Staff Report

Project Name: Santa Fe Park North – Use by Special Exception

Case Number: ENG17-0005

Applicant Request: The applicant is requesting a Floodplain Use by Special Exception for modification of the Jackass Gulch floodplain.

Figure 1 - Examples of grouted boulder Drop Structures

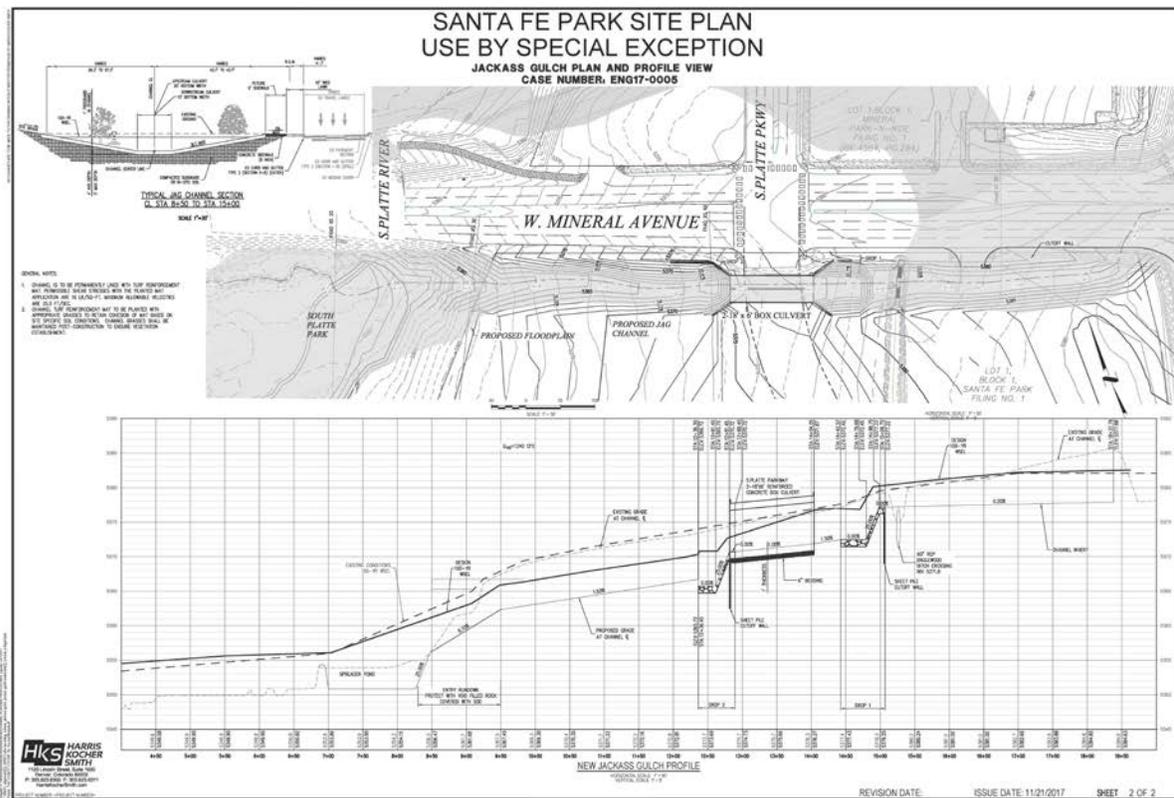
determined in the 1990 Flood Hazard Area Delineation (FHAD) study by UDFCD. Where the channel crosses beneath the new roadway extension of South Platte River Parkway (south side of Mineral), a concrete box culvert will be installed. To accommodate the elevation difference in the channel from its upstream to downstream end and maintain a stable gradient, some drop structures will be required. These drop structures are currently proposed to be constructed of grouted boulders that essentially act like mini waterfalls. Examples of drop structures are provided in Figure 1 below. The channel will be grass-lined and approximately 4' deep. Portions may be lined with a permanent erosion control blanket, which will be covered with grass. Figure 2 shows examples of grass-lined channels.
